SHEARON HARRIS NUCLEAR POWER PLANT, UNIT 1

AMENDMENT TO FACILITY OPERATING LICENSE

Amendment No. 23  
License No. NPF-63

ATTACHMENT TO LICENSE AMENDMENT NO. 23

FIGURE 3.4-2

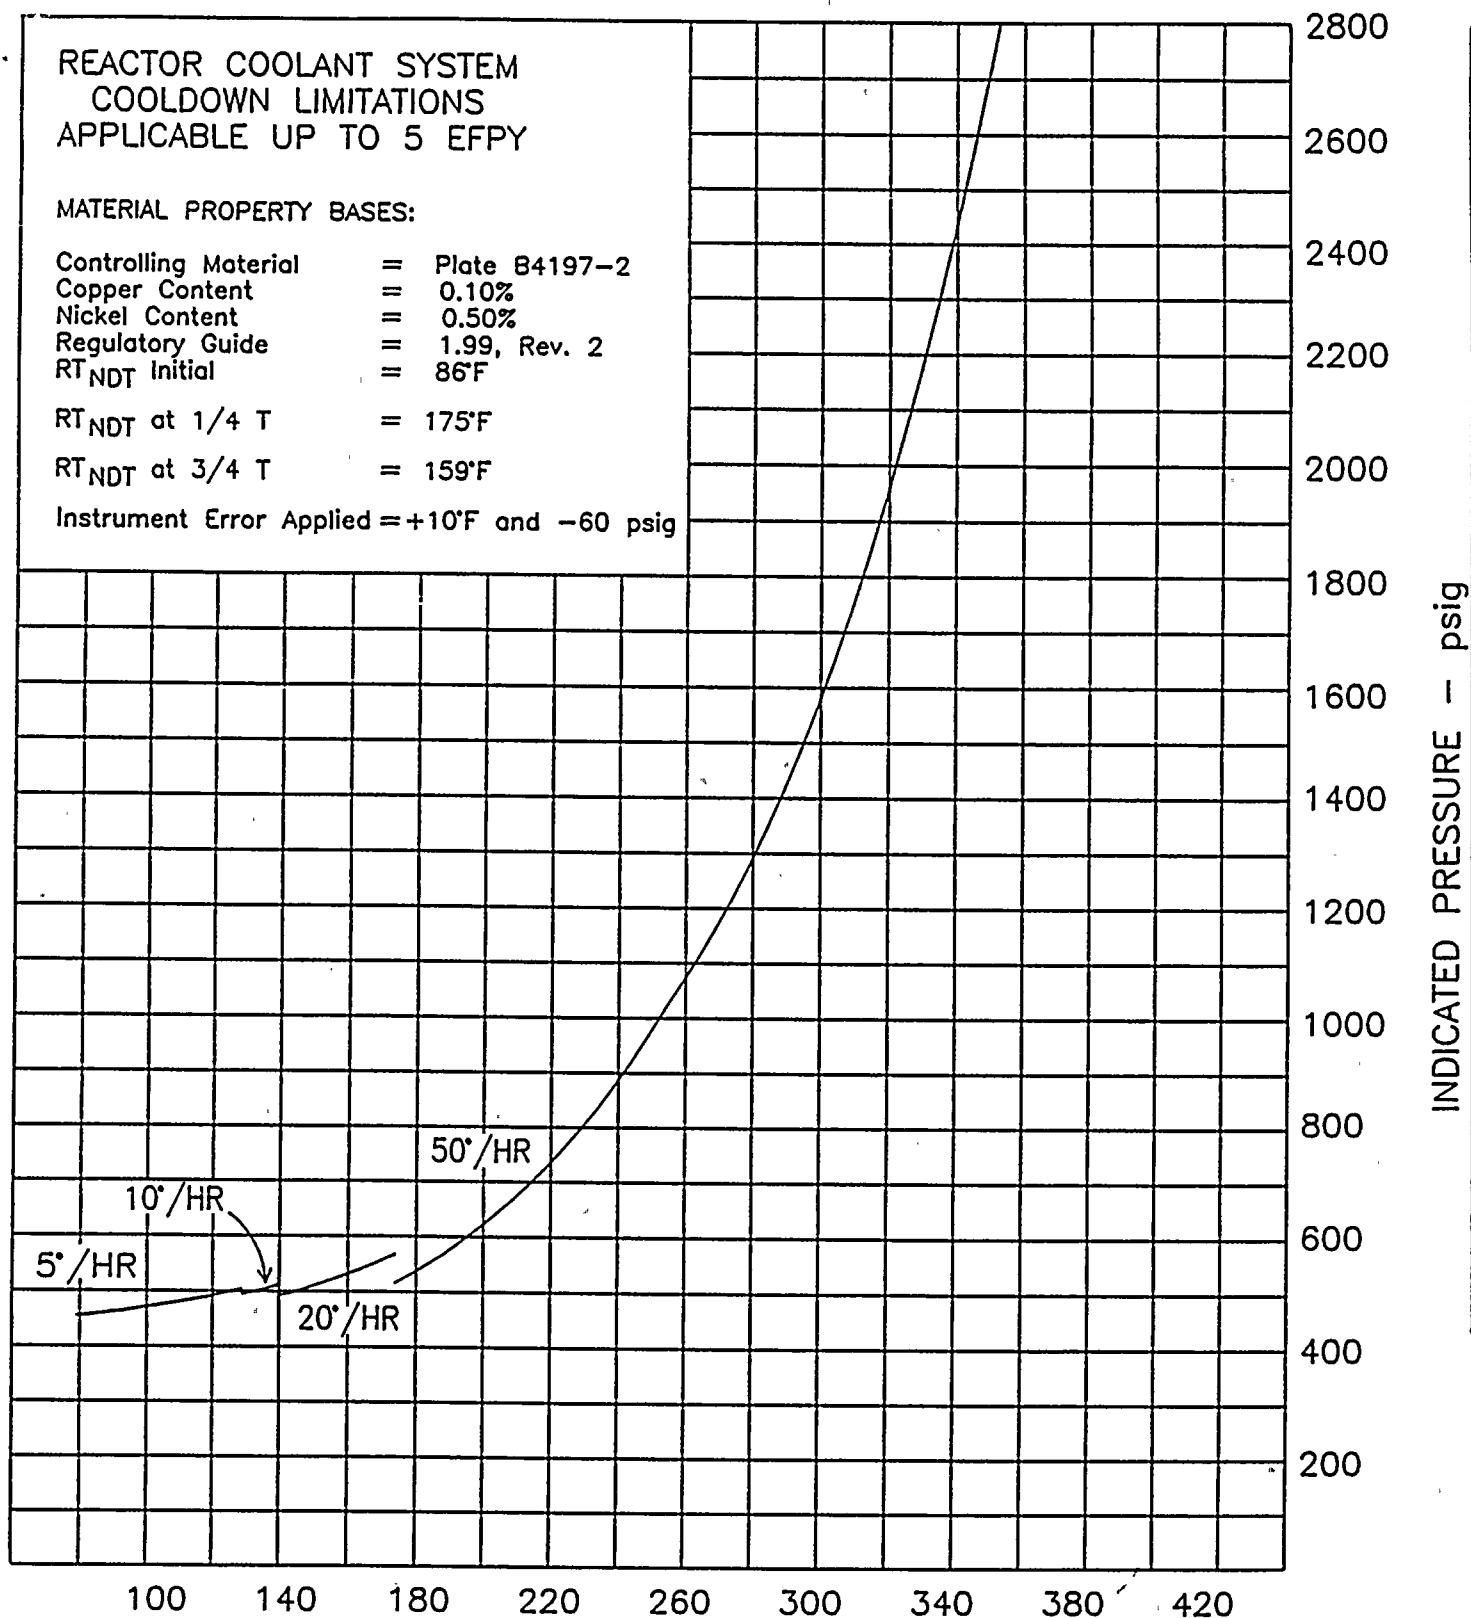
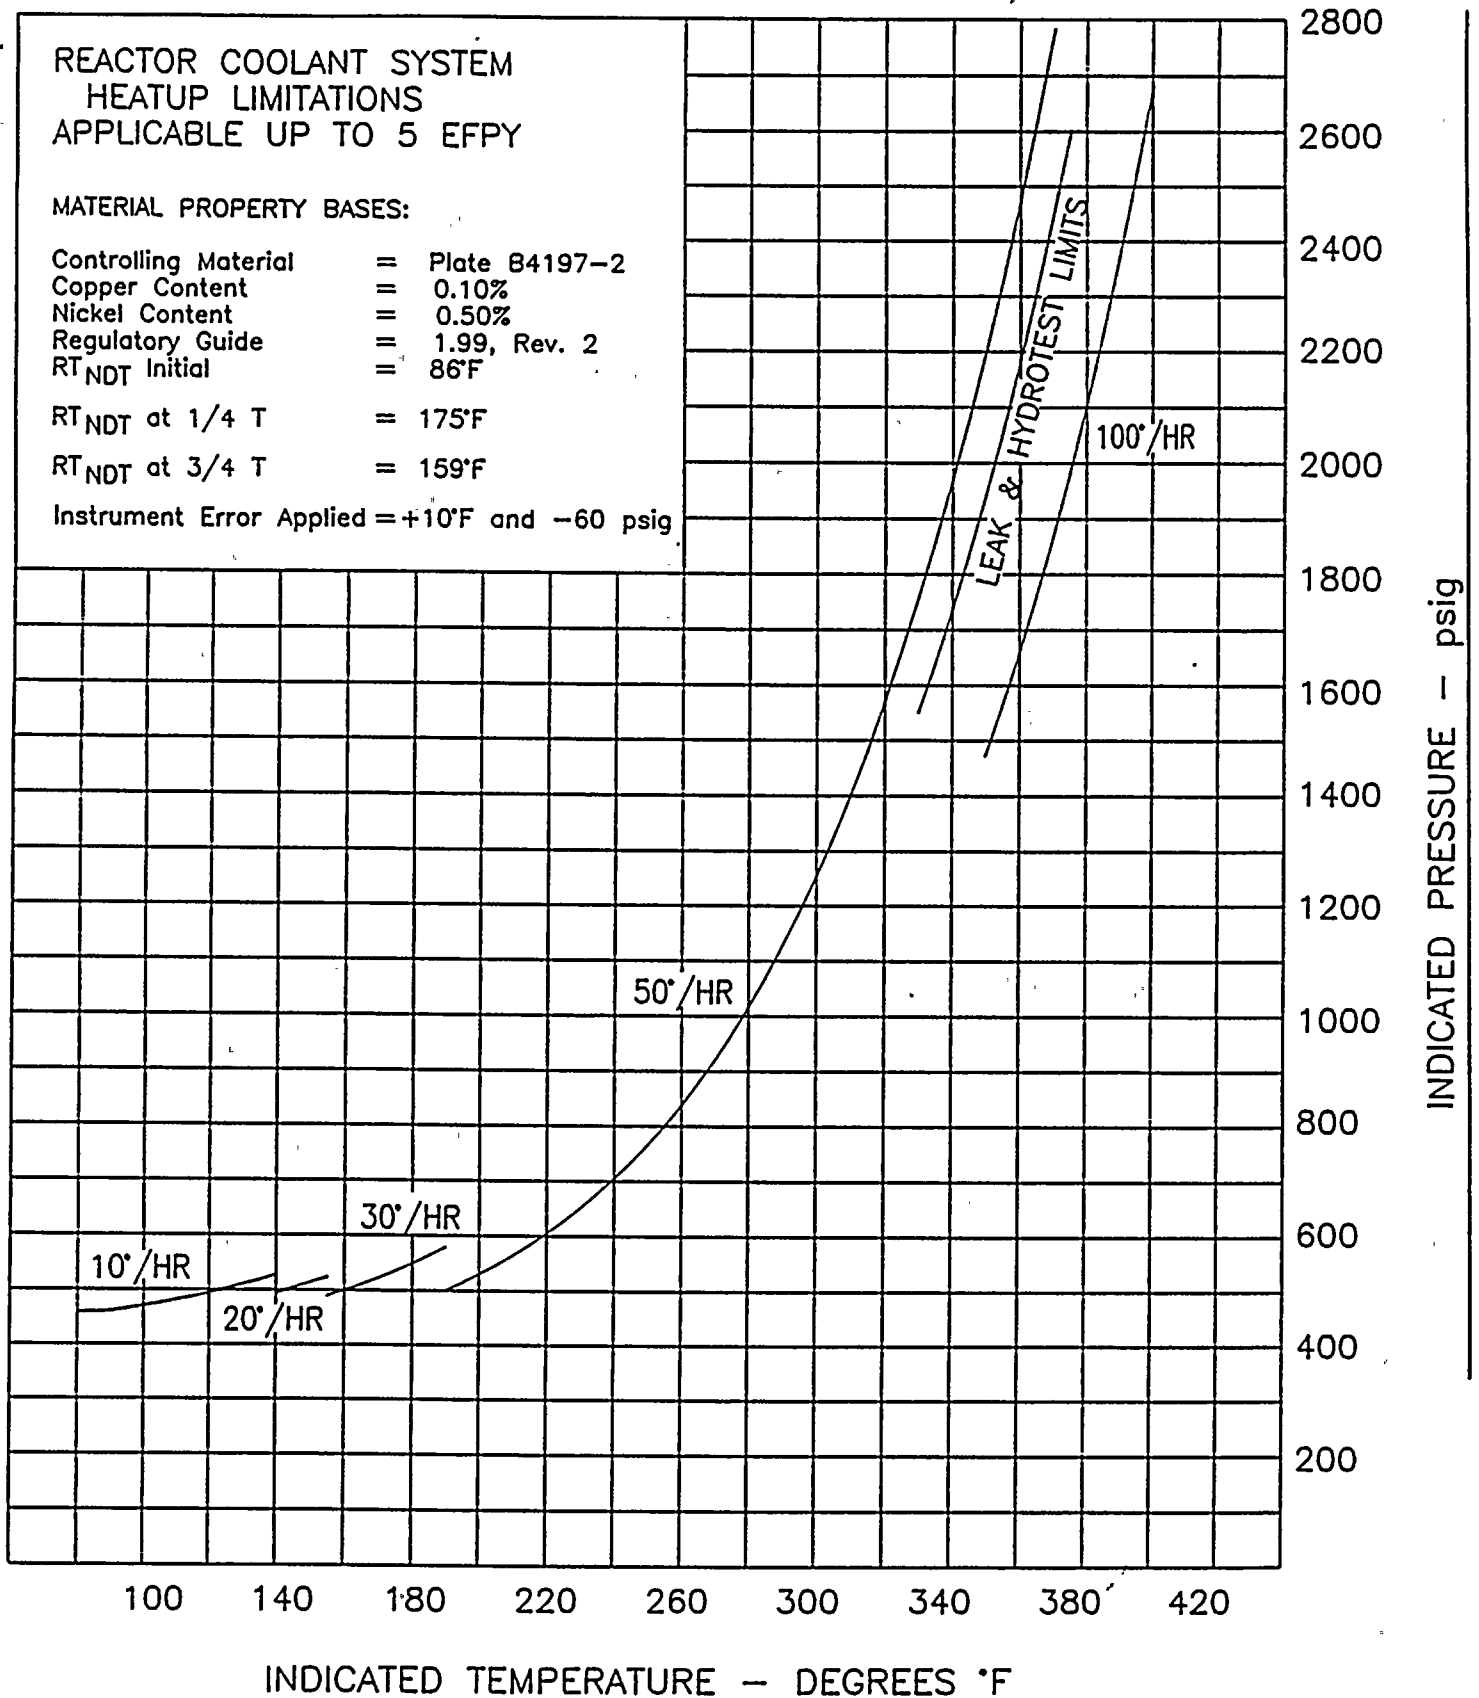
Replace the following pages of the Appendix A Technical Specifications with the enclosed pages. The revised areas are indicated by marginal lines.

Controlling Material = Plate B4197-2  
Copper Content = 0.10%  
Nickel Content = 0.50%  
Regulatory Guide = 1.99, Rev. 2  
RT<sub>NDT</sub> Initial = 86°F

RT<sub>NDT</sub> at 1/4 T = 175°F

RT<sub>NDT</sub> at 3/4 T = 159°F

Instrument Error Applied = +10°F and -60 psig
